# High-Strength Bolts for Bridges

Report No. FHWA-SA-91-031

## Addendum

(date of Addendum: April 14, 1994)

2 - 13

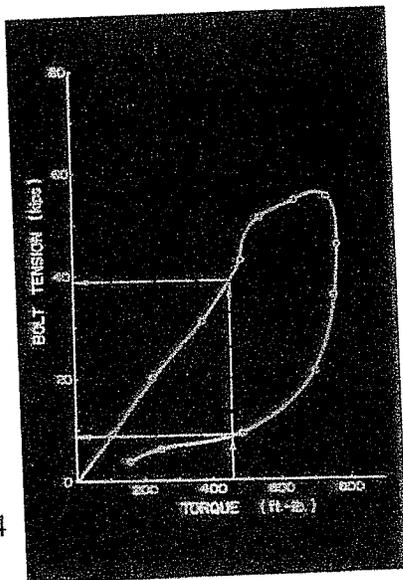
2-13

A325/M164  
Type 1 & 2  
Type 1 Galv.

Matching Nuts  
A563/M291  
C, C3, D, DH, DH3  
DH

A194/M292  
2, 2H  
2H

6 - 17

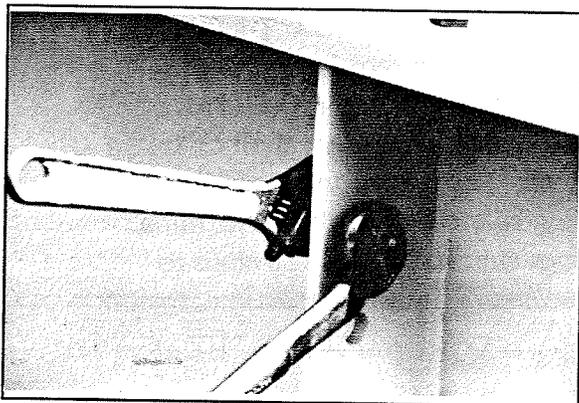
- 6-20 Change slide: "P = "turn test tension" from Table D4.1g.
- 7- 2 AASHTO Bridge code is now 15th edition, with Interim  
7- 4 Specifications issued annually.

8 - 2

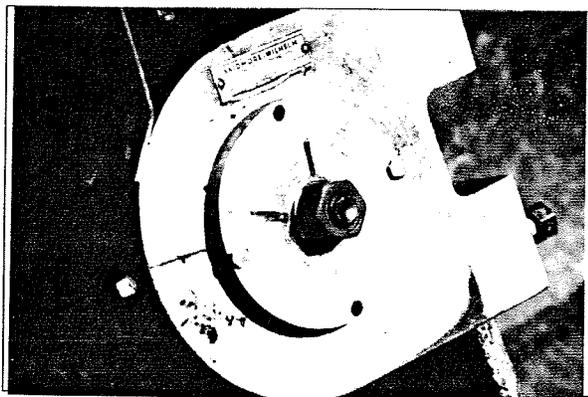
- 8- 3 Change text: "Table 10.17A" to "Table 11.5A".
- 8- 6 Change slide and text: "Table 10.17B" to "Table 11.5B".
- 9- 5 For bridge applications, the typical gap is 0.005 inches.
